September 5, 2019

RE: 180 East Third Avenue

I reviewed the drawings, evaluated the site context, viewed the video of the November Planning Commission Study Session and prepared review letters on April 11, May 27 and August 6. My comments on the revised plans and elevations for this project are as follows:

STREET FACADES COMPARISON

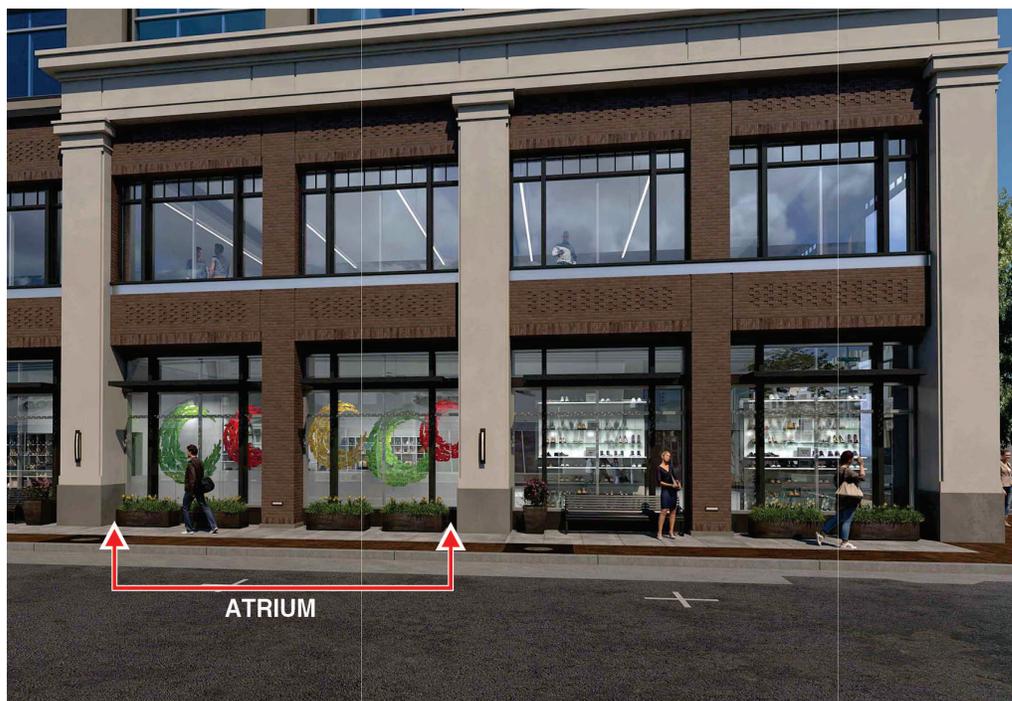
CURRENTLY PROPOSED DESIGN

Current Atrium Ground Floor Plan

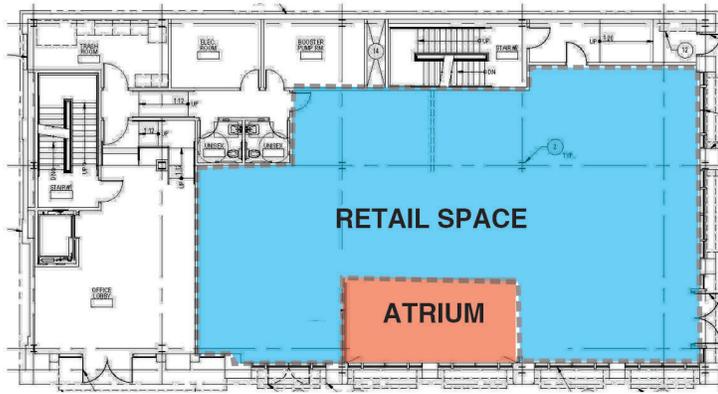
1. Atrium intrusion into the ground floor retail space

Planning staff has continued to work with the applicant on this issue. New sketches have been provided to better illustrate the impact of the atrium on the pedestrian experience along the Ellsworth Avenue frontage. These sketches are shown below and on the next page.

Recommendation: Staff feels comfortable with the proposed atrium as it relates to its impact on the pedestrian experience.

Examples of Historic District structures with paired second floor vertical windows and awnings

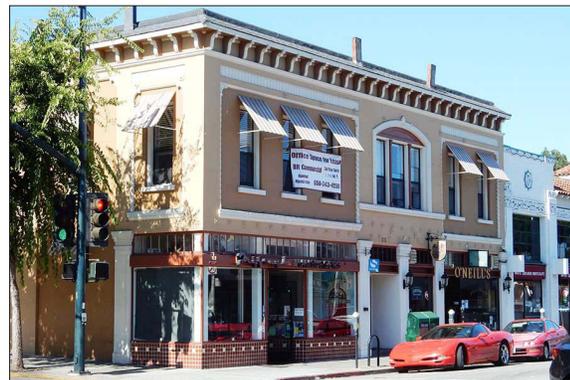
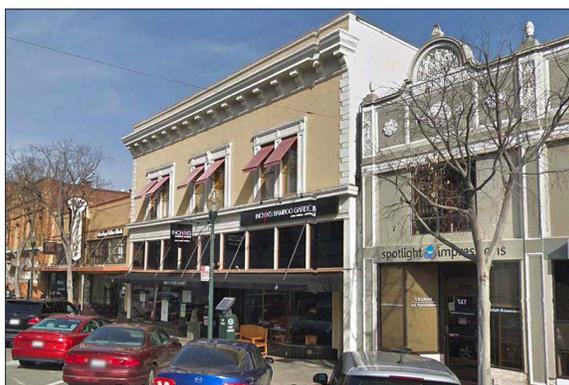
2. Second story window proportions

The recommendation in both the April 11 and May 27 review letters was to reduce second floor window sizes and add interesting architectural details in order to place greater emphasis on the second floor street facades to lessen the prominence of the third floor stucco facades - see previous recommended East Third Avenue illustration below and Downtown San Mateo examples.

Recommendation: After consultation with planning staff, my recommendation would still be to provide the smaller paired windows at the second floor.
